Department of City Development, City of Milwaukee

Request for Proposal #57336
General Contracting Services
Housing Infrastructure Preservation (HIP)

Addendum #1
March 16, 2012

EAST PORCH ELEV.

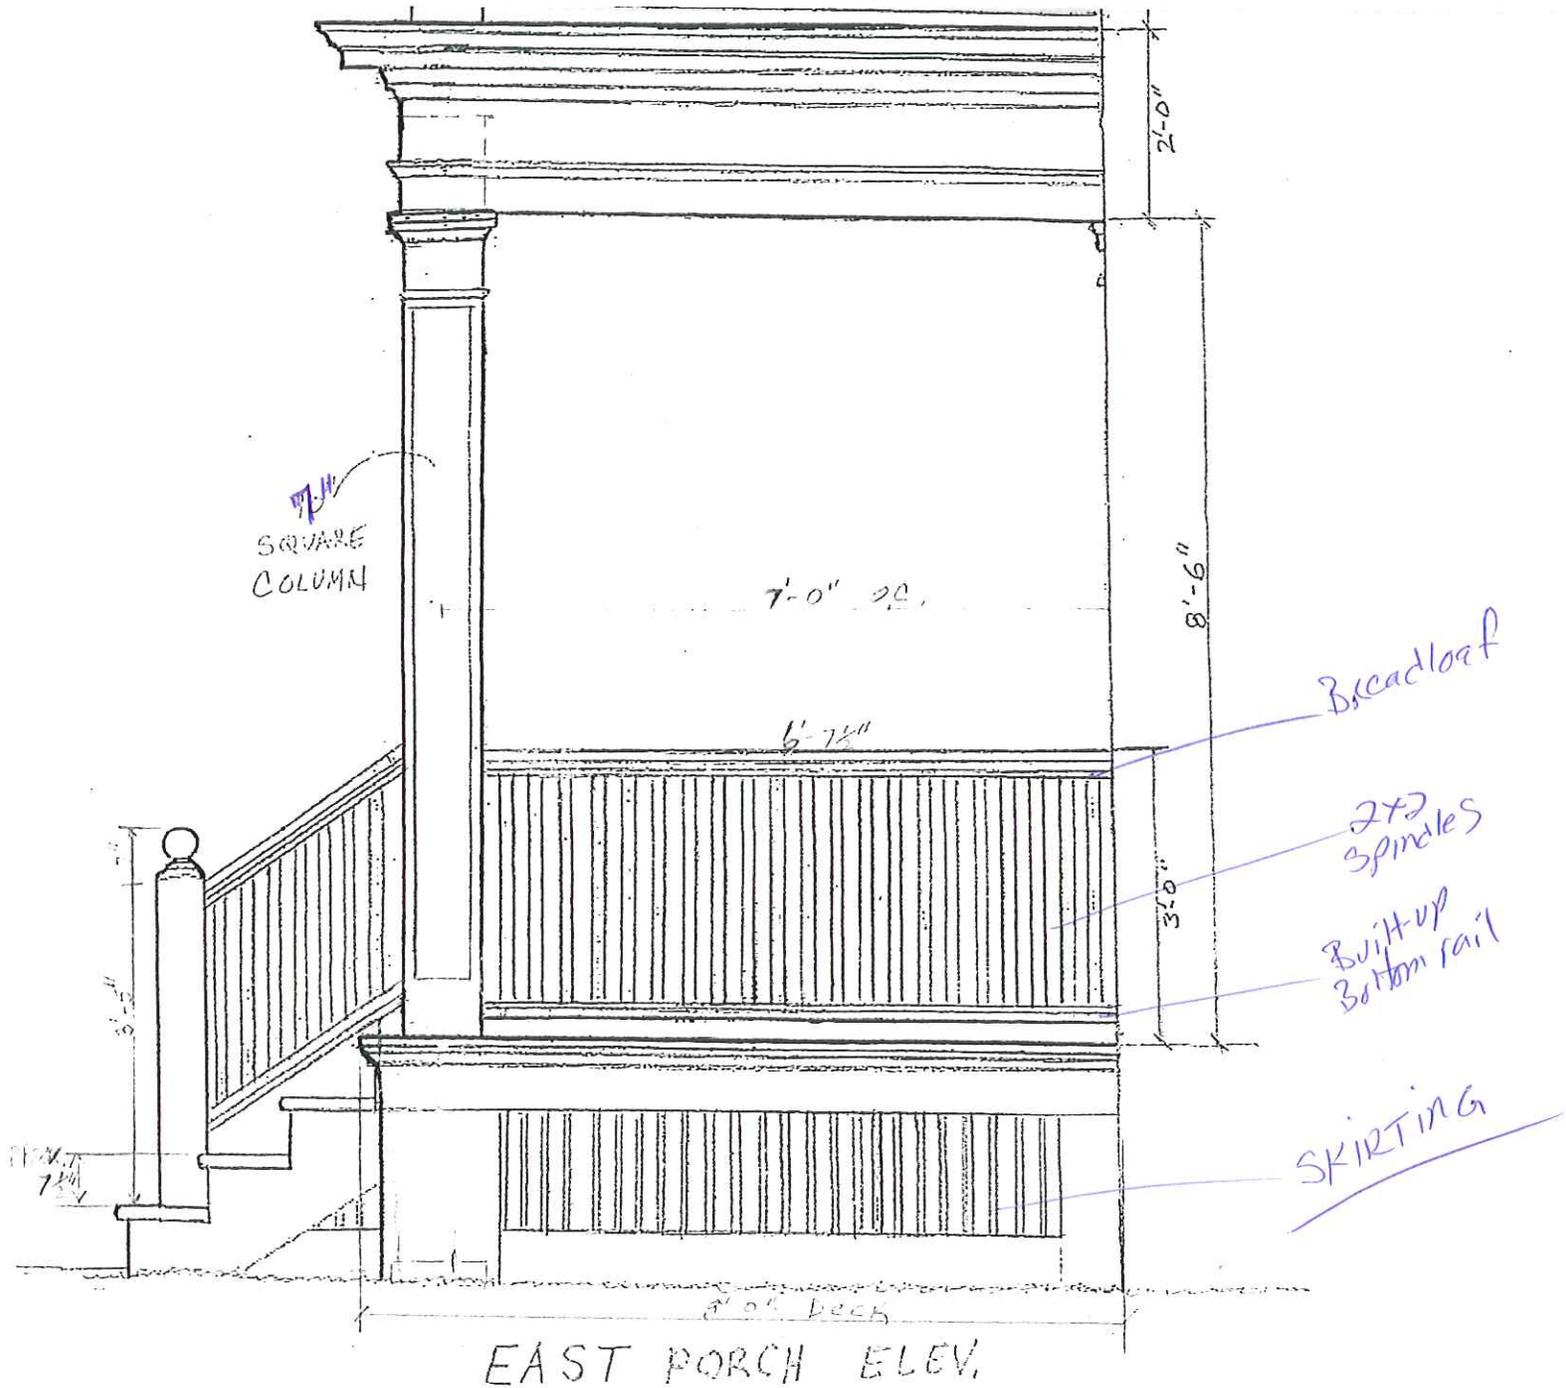
Attached please find the drawing for the porch that was referenced in the Scope of Work.

Question 2: In reference to the materials being used for the front porch, is there a particular material that you want us to use per item? For example slats, stringers, spindles, framing, skirt framing?

Answer 2: DCD is looking for a porch rebuild similar to the porches of the city owned properties located at 2808 West Wells street and 2812 West Wells Street.
